Village of Arlington Heights
Plan Commission
Community Room, 3rd Floor
Arlington Heights Village Hall
33 S. Arlington Heights Road
Arlington Heights, IL 60005
August 23, 2017
7:30 PM

VILLAGE OF ARLINGTON HEIGHTS **STAFF DEVELOPMENT** **COMMITTEE REPORT**

PC Project Number: PC 17-007
Project Title: Greenbrier School Addition
Address: 2330 N. Verde Dr.
PIN: 03-18-112-003

C2.01

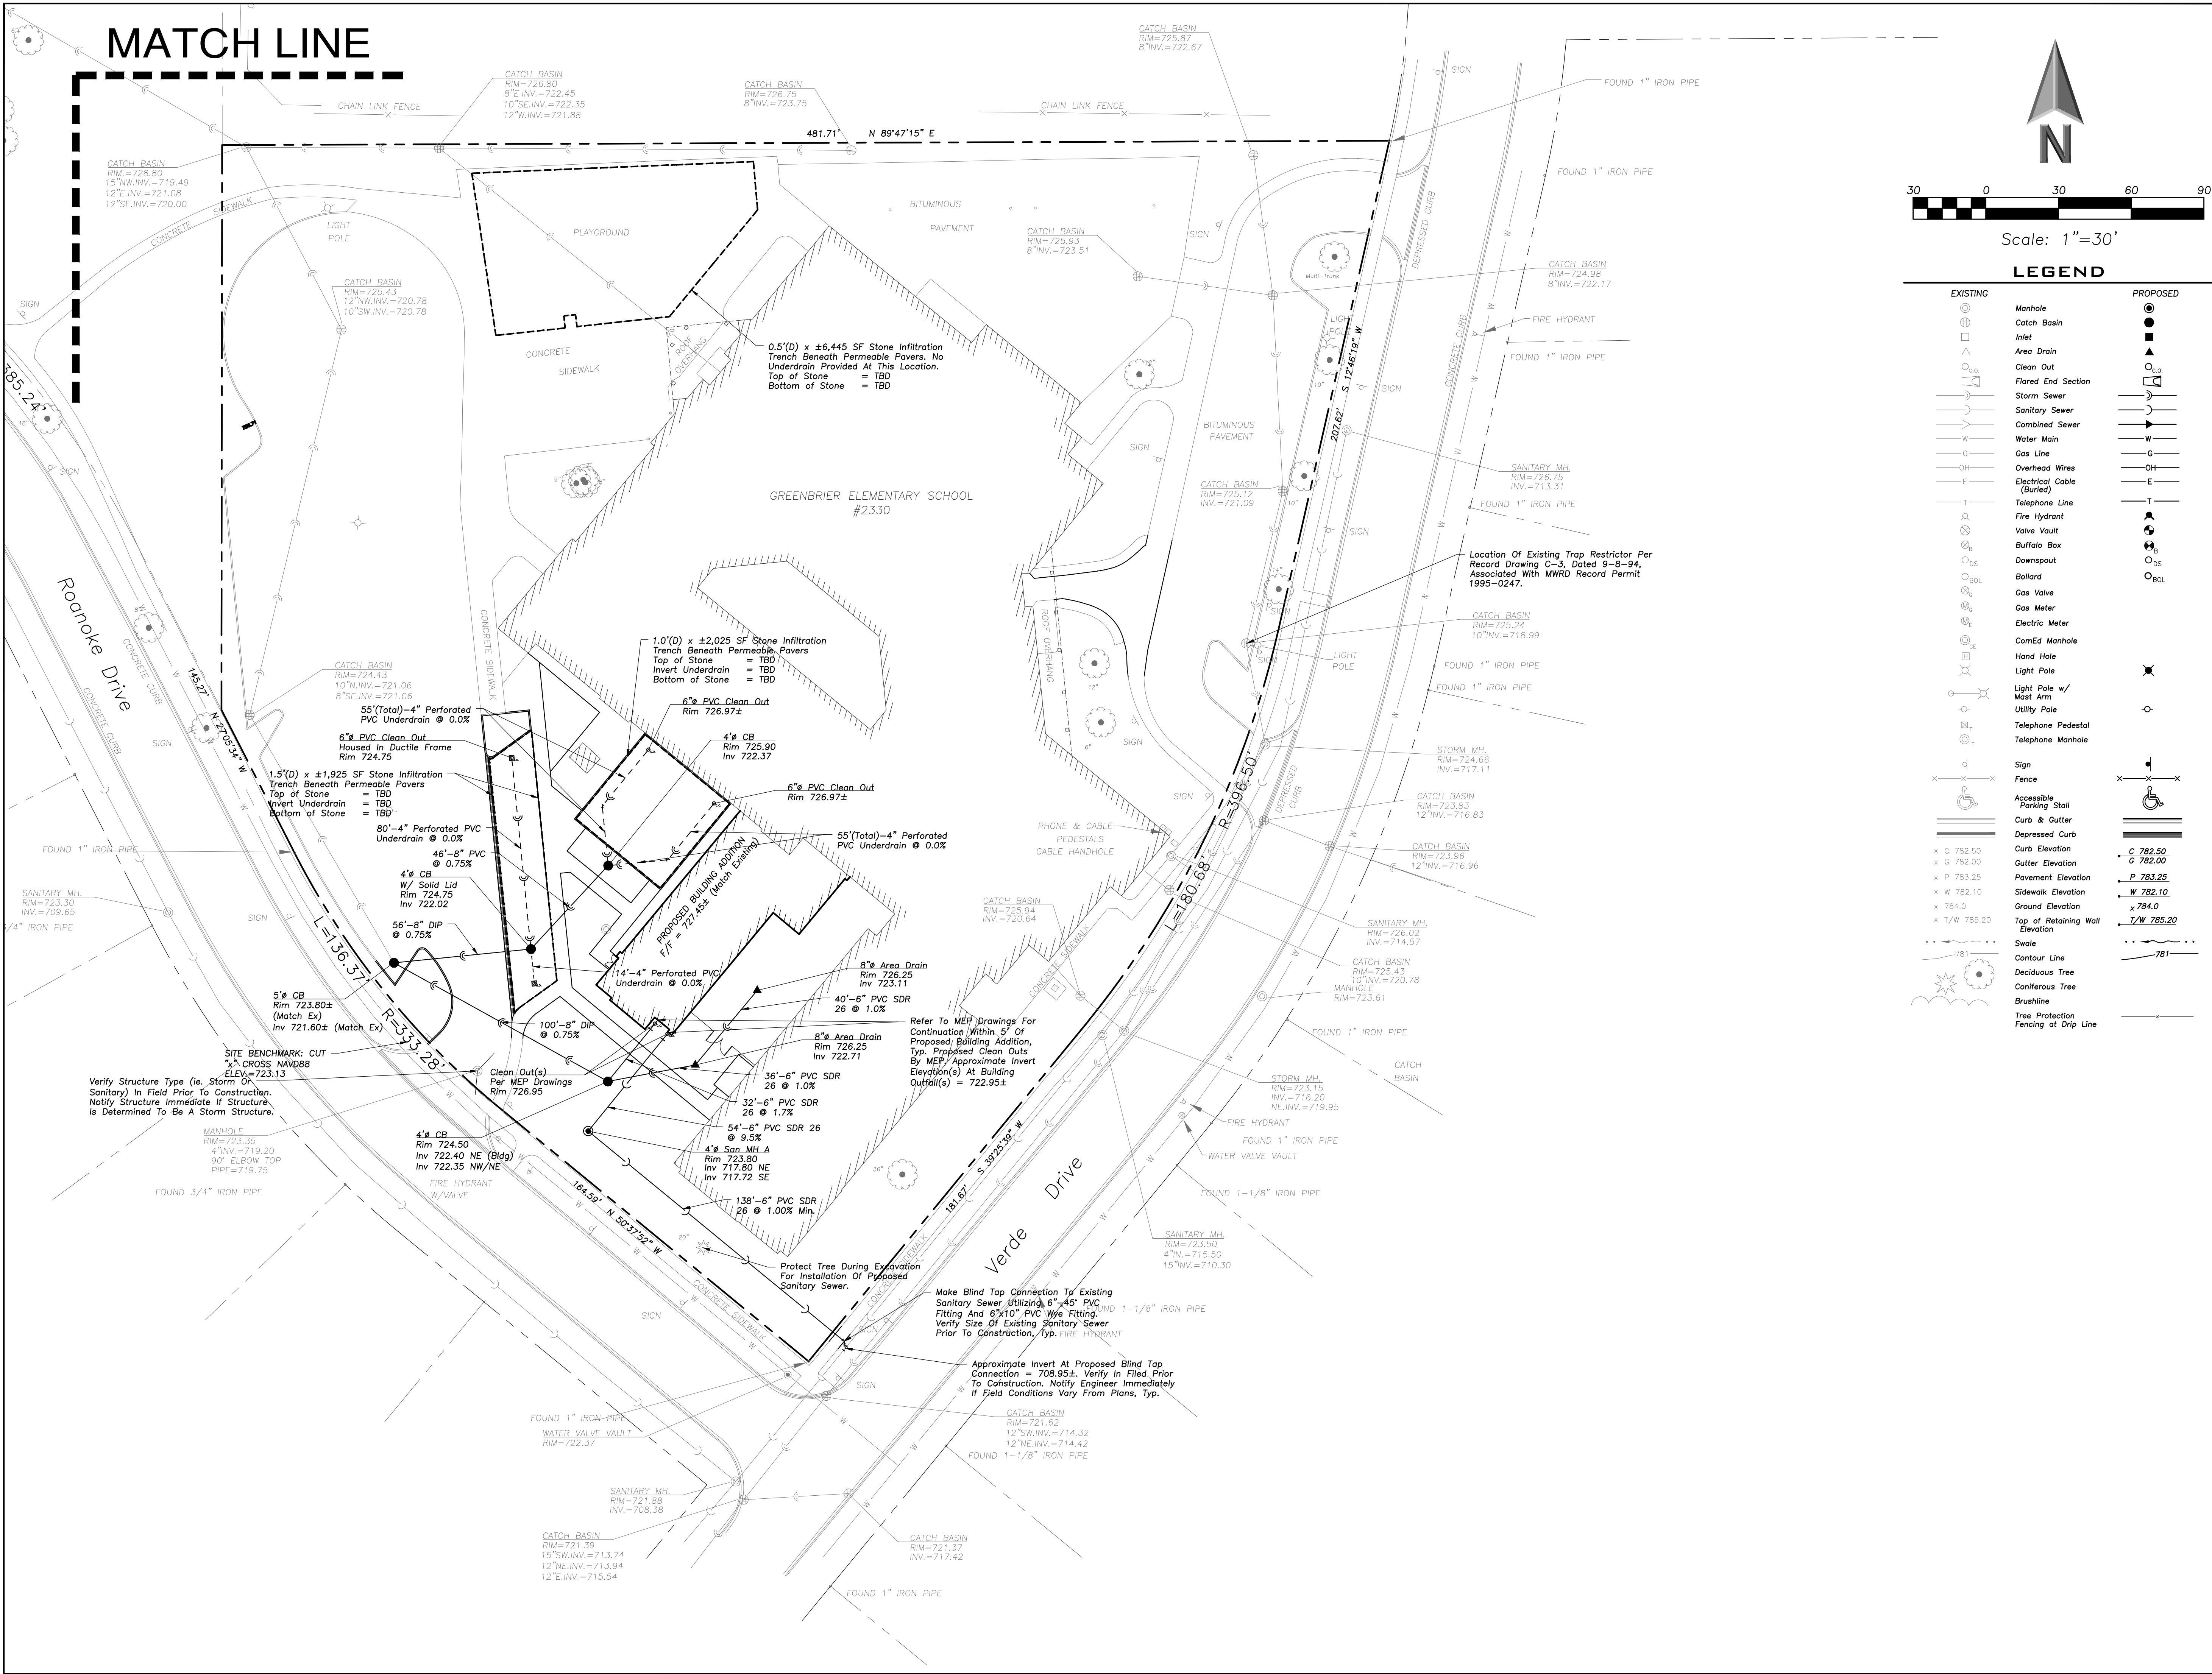
16. Please revise the Site Geometry Plan (sheet C2.01) to show the setbacks of the existing building to the north, south, east, and west at its closest points.

Response: The setbacks of the existing building to the north, south, east, and west are added to sheet C2.01.
